INDIANA DEPARTMENT OF TRANSPORTATION

Design Memorandum No. 21-25

SUBJECT: Mechanically Stabilized Earth (MSE) Walls

REVISES: *Indiana Design Manual (IDM) Chapter 14, Sections 14-2.01(07), 14-2.01(12), 14-2.04(06), 14-2.04(09), 14-2.05(05)*
Indiana Design Manual (IDM) Chapter 17, Figure 17-5C
Indiana Design Manual (IDM) Chapter 402, Section 402-6.02(02)
Indiana Design Manual (IDM) Chapter 409, Figure 409-2G
Indiana Design Manual (IDM) Chapter 410, Section 410-5.01(06) and Figure 410-5(O)C
Editable Document: MSE Wall Design Review Checklist

Figure 17-5C

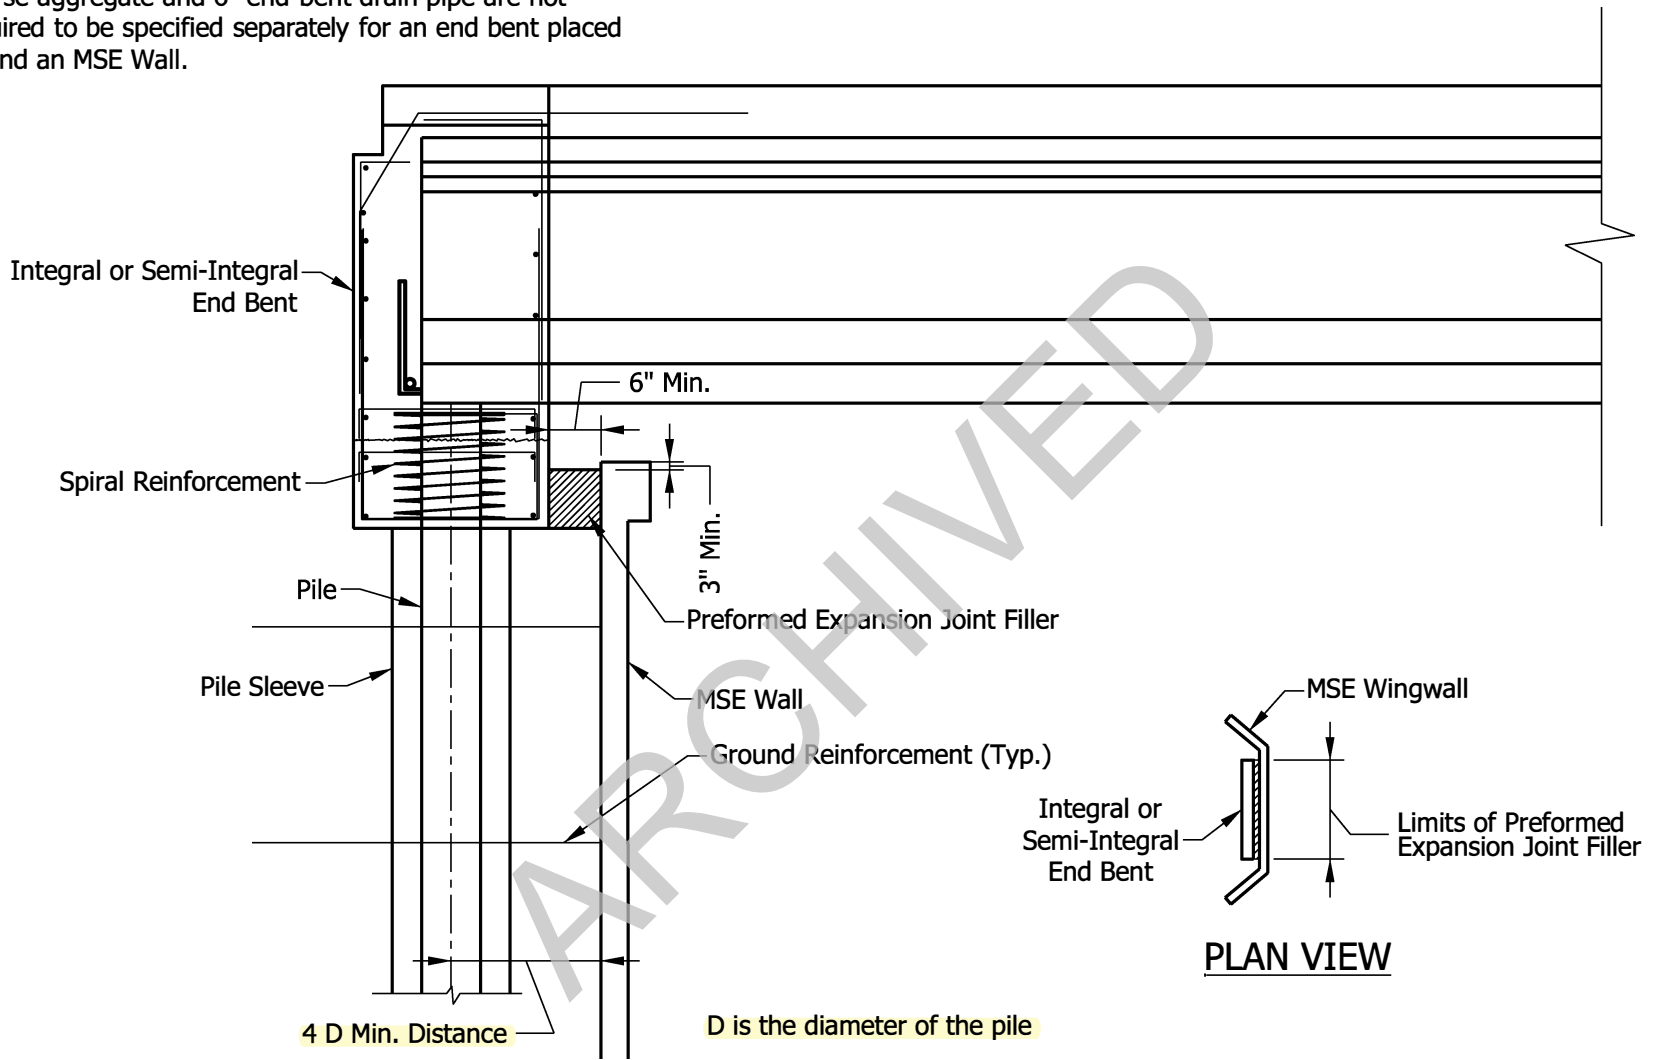
Coarse aggregate and 6" end-bent drain pipe are not required to be specified separately for an end bent placed behind an MSE Wall.

**Figure 409-2G
(Page 1 of 3)**

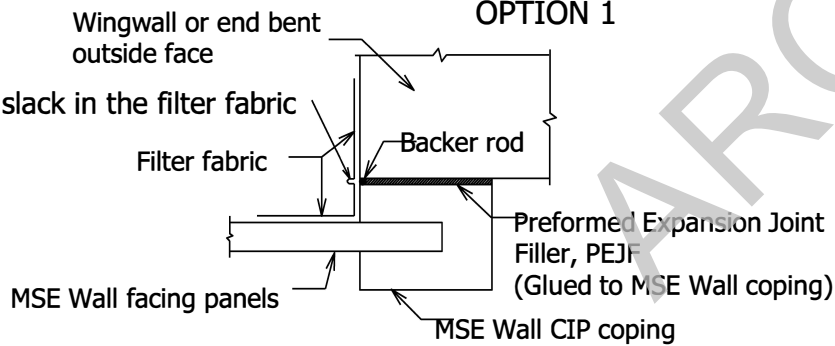
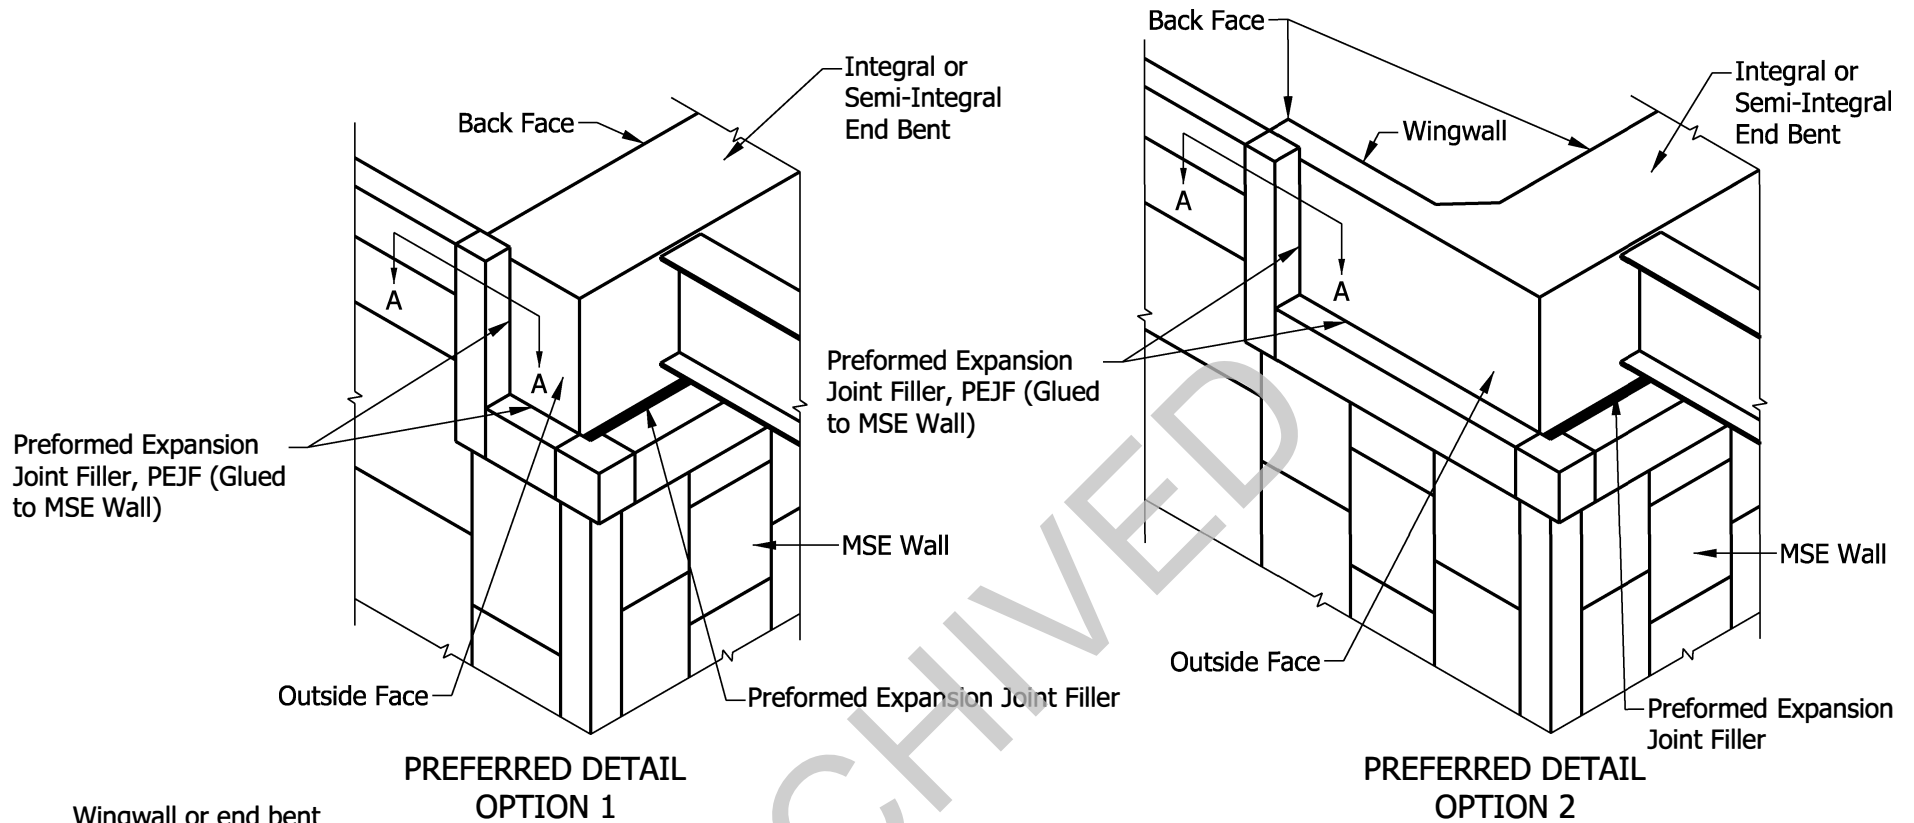
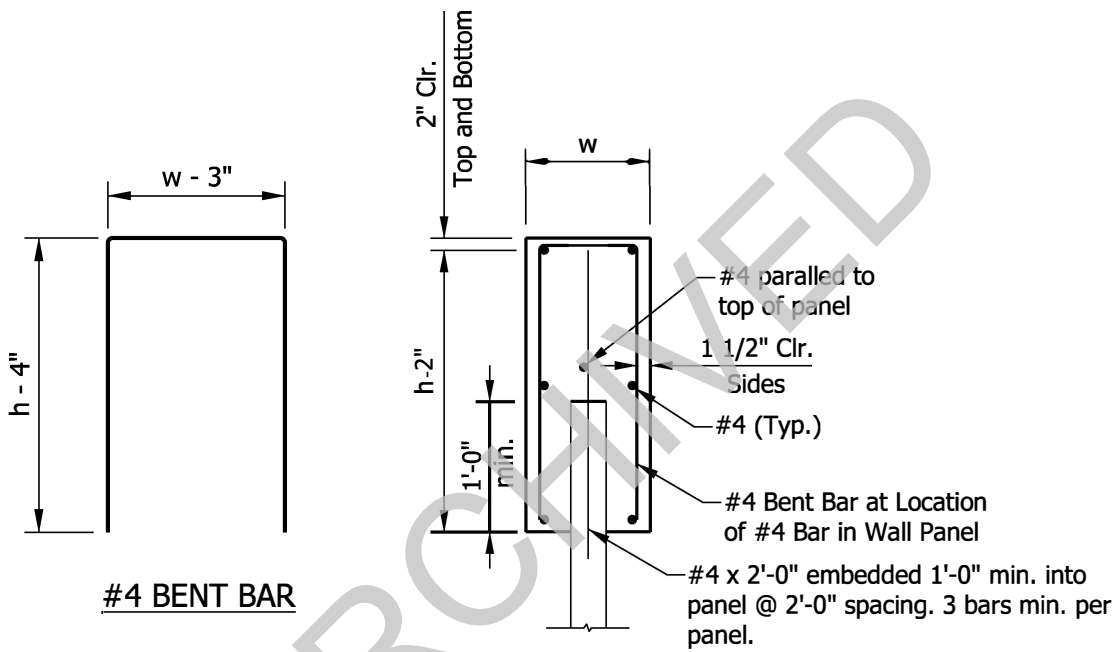
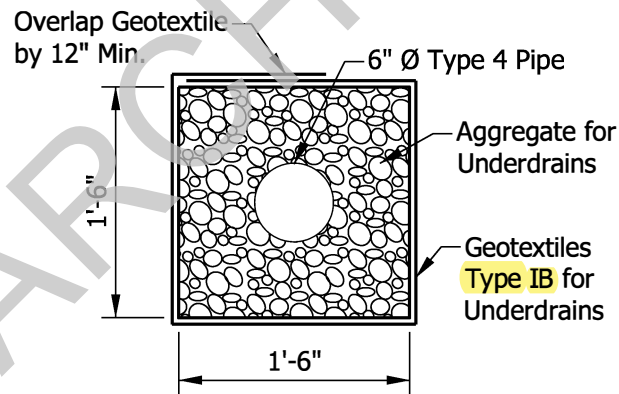
In addition, Chapter 402 of the *Indiana Design Manual* has been revised to update the minimum distance between the back of the MSE Wall panel and the center of the pile to 4 times the diameter of the pile.

Figure 410-5(0)C

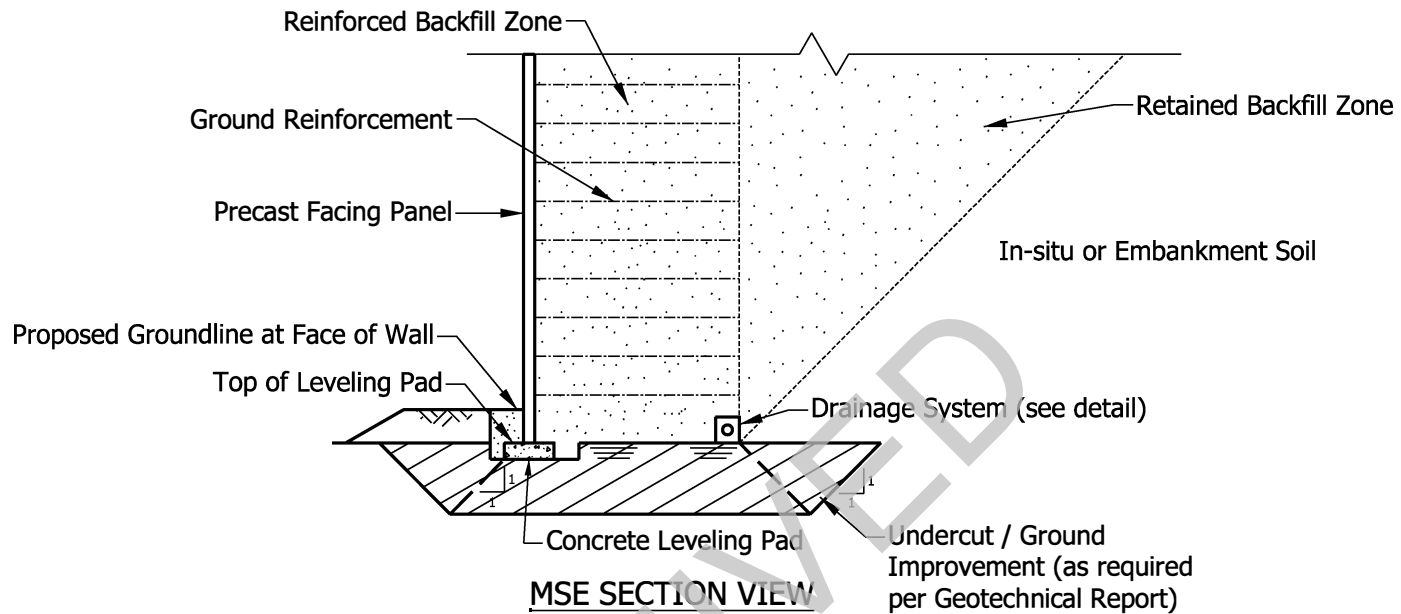
Figure 410-5(0)C	Typical MSE Wall Cross Section	Includes the requirement to use Geotextile Type IB for underdrains.
Editable Document	MSE Wall Design Review Checklist	Updates the relevant sections in accordance with the revised section of Indiana Design Manual.
